# Access Compliance Report

## Public Rights-of-Way

### (Curb Ramps)

Intersection ID: 7826	Main Street: BROOKSHIRE_BV	Cross Street: DAKOTA_ST	Location:	N
ADA ID: 3D51F086314C	Ramp Type: Perp	Initial Pass/Fail: Fail	Overall Compliance: No	Severity Score: 22.5
Codes/Mitigation Info/Possible Solution		Field Measurements/Component Compliance

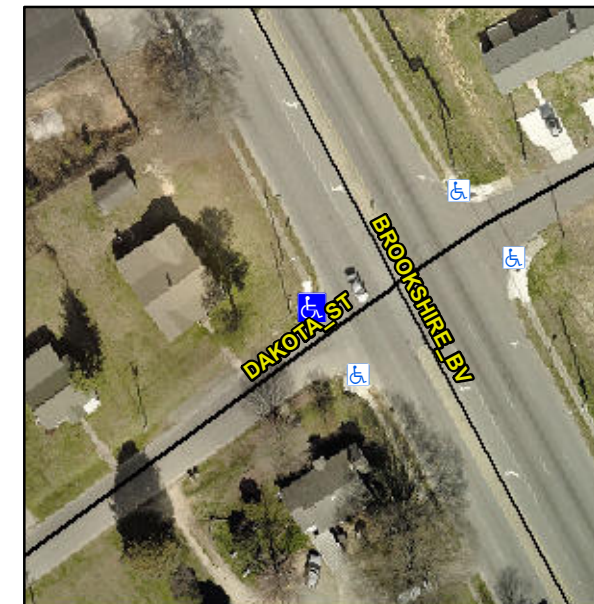
**Not Found, R304.5.1, R304.2.2, R304.5.3**

Compliance	Description	Data	Compliance	Description	Data
N/A	Ramp Length (in)	75.0	No	Ramp Slope (%)	8.7
No	Ramp Width (in)	46.0	No	Ramp XSlope (%)	2.6
N/A	Flare Type LT	N/A	N/A	Flare Type RT	N/A
N/A	Flare Slope LT (%)	N/A	N/A	Flare Slope RT (%)	N/A
N/A	Flare Traversable LT?	N/A	N/A	Flare Traversable RT?	N/A
N/A	Landing Length (in)	N/A	N/A	DWS Provided?	N/A
N/A	Landing Width (in)	N/A	N/A	DWS Contrast?	N/A
N/A	Landing Slope (%)	N/A	N/A	DWS Length (in)	N/A
N/A	Landing X Slope (%)	N/A	N/A	DWS Full Width?	N/A
N/A	Landing Curb? (Y/N)	N/A	N/A	DWS Offset (in)	N/A
N/A	Shared Landing?	N/A			
N/A	Gutter Ponding?	N/A	N/A	Gutter Slope (%)	N/A
N/A	Gutter Lip Ht (in)	N/A	N/A	Gutter X Slope (%)	N/A
N/A	Painted X Walk1?	No	N/A	Painted X Walk2?	N/A
	X Walk 1 Direction	To SE		X Walk 2 Direction	N/A
N/A	X Walk 1 Width (in)	N/A	N/A	X Walk 2 Width (in)	N/A
	X Walk 1 Slope (%)	4.3		X Walk 2 Slope (%)	N/A
	X Walk 1 X Slope (%)	2.7		X Walk 2 X Slope (%)	N/A

**Remove & Replace Entire Ramp.**
